Access Compliance Report Public Rights-of-Way (Curb Ramps)

Main Street: FOLLATE_WAY		Cross Street: FOLLATE_WAY		Location:	W
ADA ID: RPRK220225191638	Ramp Type:Type 1 - Perpendicular	Initial Pass/Fail: Fail	Overall Compliance: No	Severity Score:	19

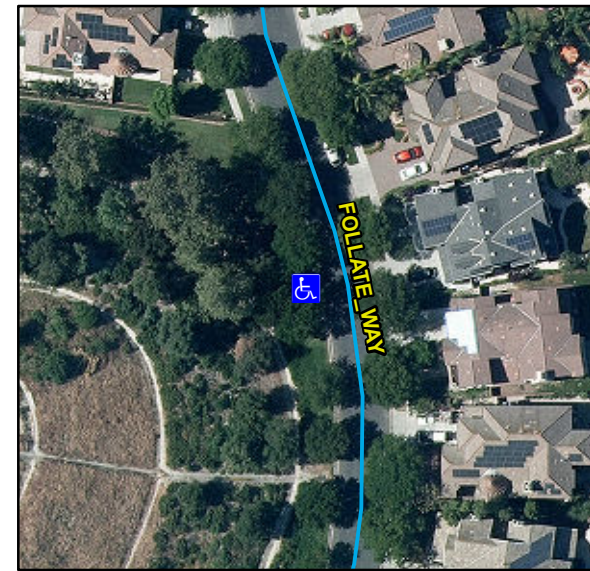
R304.2.2, R304.5.1, STD 1115

Remove & Replace Entire Ramp.
